| Flight Procedures Cover Page | Task Action: FLIGHT CHECK | Task Type: IAP | Estimated Chart Date: 10/02/2025 | APWS Task ID: EC70D8574FF449B6BBCFDE45035B0E7F | APWS Project ID: 7276DB49E01C46CBAE5E7810018A97CC |
| Procedure: ILS OR LOC RWY 27L AMDT 38 | | Enroute: NO | Specialist: Keefer, John | | Agreement Number: |
| Airport ID: KSBN | | | Airport City: SOUTH BEND | | State: IN |

ILS RWY 27L (SA CAT I & II) SOUTH BEND INTL (SBN)

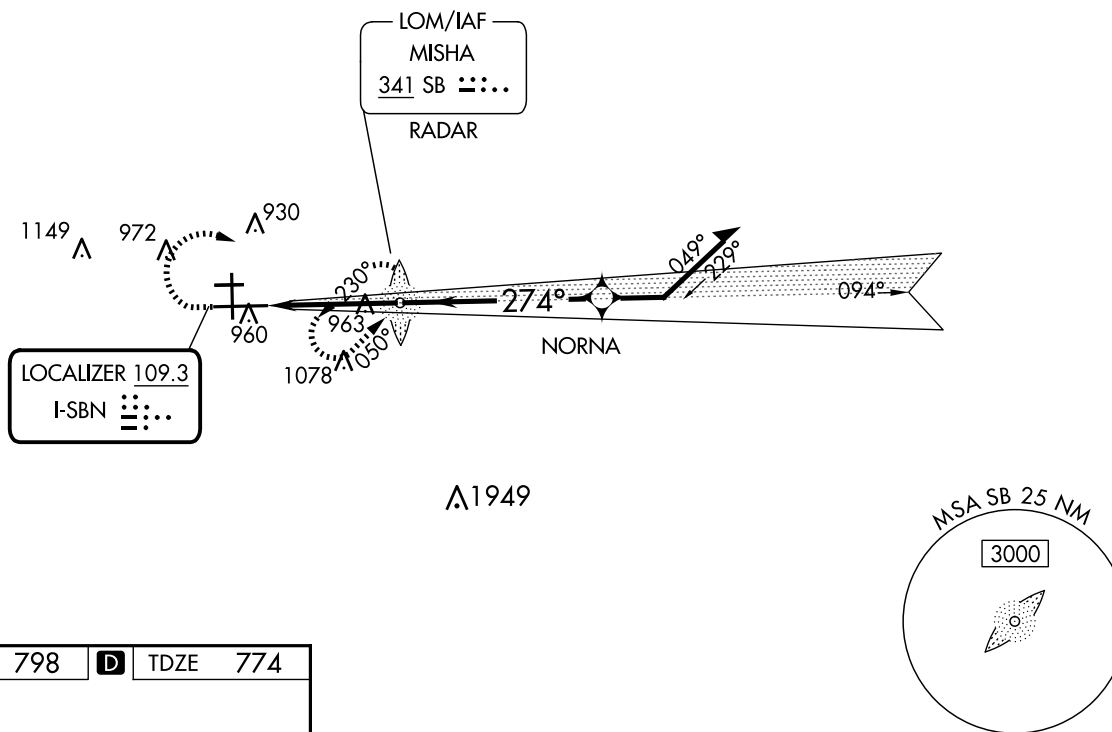
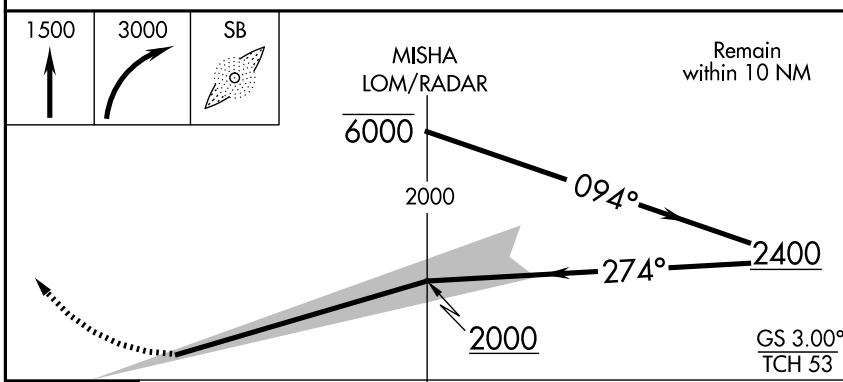
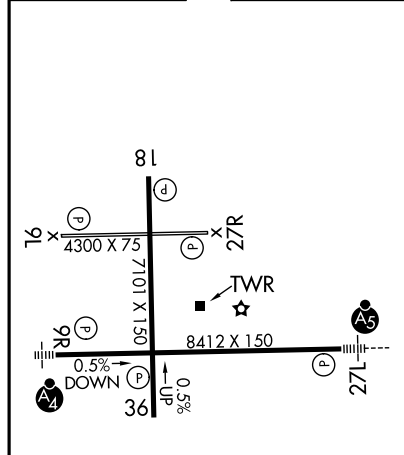
Add NORNA (IF) to MISHA LOM (FAF) to create an RNAV intermediate route.

09/11/25: THIS IS A CORRECTED COPY OF THE FORM APPROVED ON 09/10/25.
1. REMOVED NORNA 2400 FROM LINE 4
